ADDENDUM

Project Name: Hendrick Basin Outfall Sewer Replacement Project

Addendum Subject: Manhole 04300714 Drop Construction

Addendum No.: 1

OUTSIDE STANDARD DROP
MANHOLE

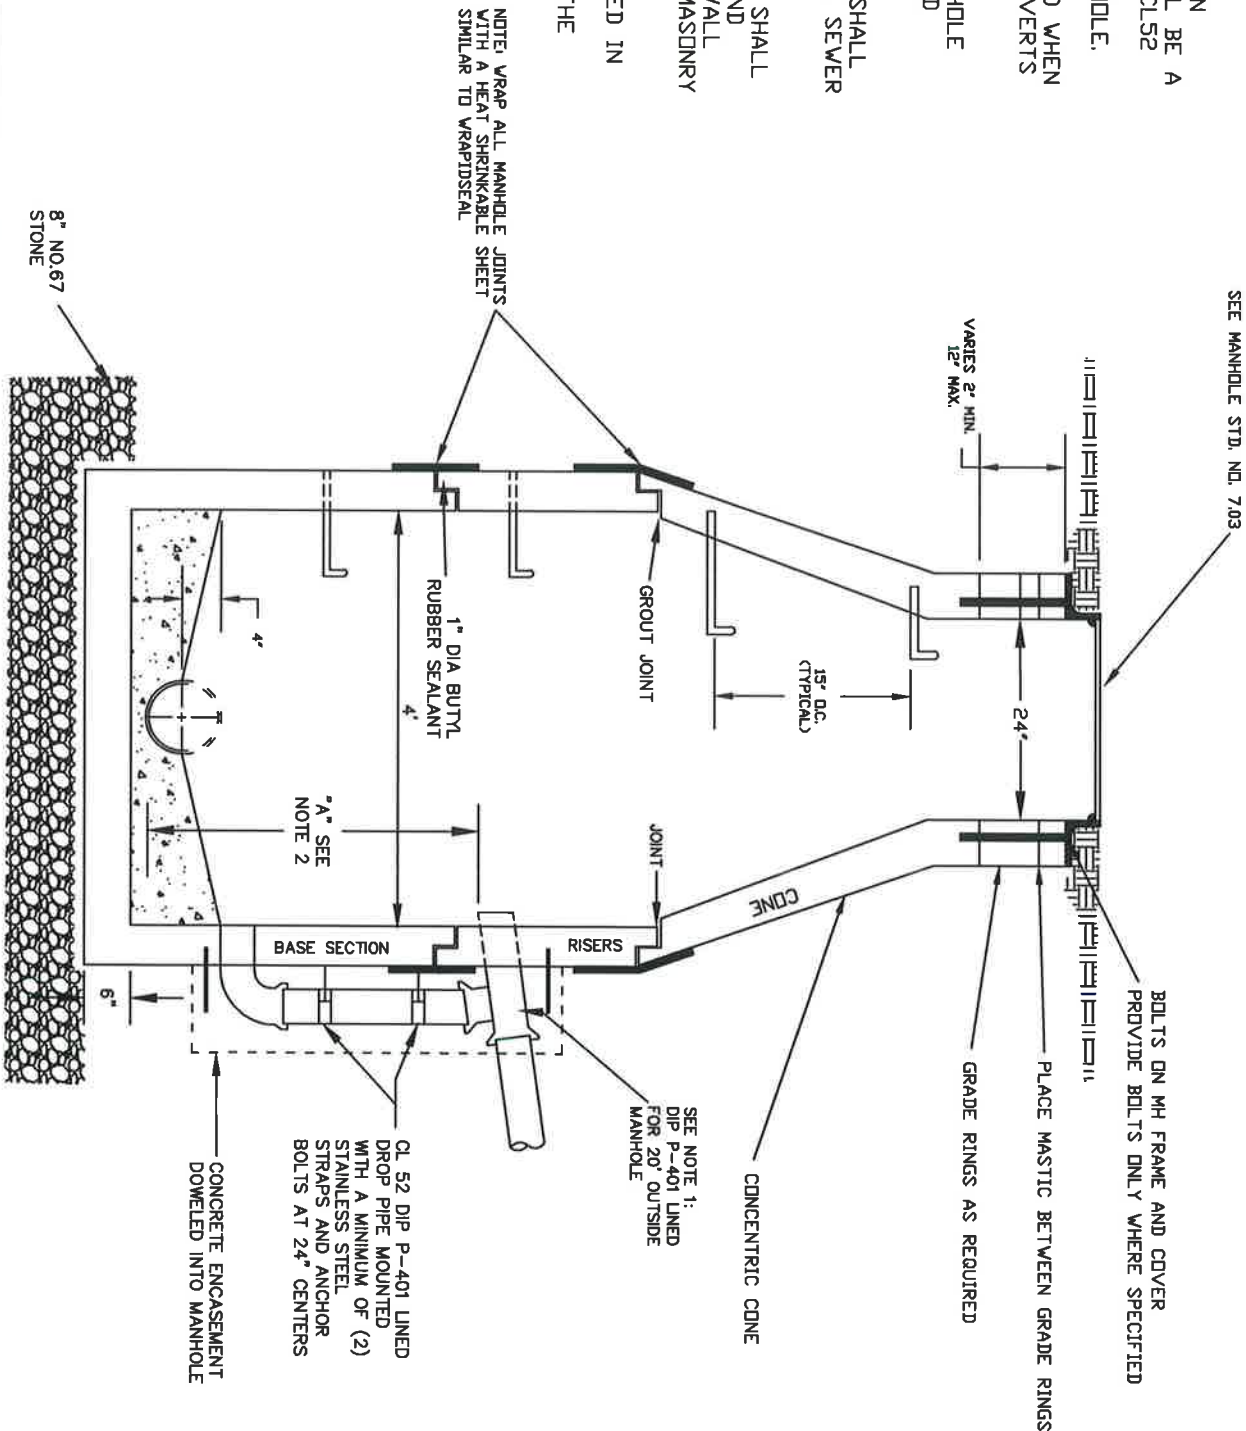
- This addenda item addresses the sewer manhole number 04300714, which currently has an incoming line with an 8-foot drop into the manhole from the north. This manhole will need a new outside drop constructed so that the incoming flow does not drop directly into the manhole. Additionally, the ductile iron pipe material used to build the proposed drop shall be run one full pipe length to the north and tied back into the existing sewer line segment.

- The outside drop manhole pipe material shall be 10-inch Class 52 Ductile Iron with the Protecto 401 liner. The upstream section of the outside drop shall be one full length of 10-inch Class 52 Ductile Iron Protecto 401 lined pipe and tied back into the existing 10-inch sewer main using a max adaptor (Fernco Couplings are not allowed). Installation of the outside drop pipe shall conform to the City of Shelby Standard Detail Outside Standard Drop Manhole, 7.04. All mechanical joints and restrained fittings used on the drop shall be ductile iron material with P401 lining.

- Sewer manhole number 04300714 is approximately 13-feet deep with the lower invert of the outside drop being a part of the manhole bottom invert and the upper outside drop invert being approximately 8-feet from the bottom of the manhole invert. All manhole depth and inverts are approximate and shall be verified by the contractor.
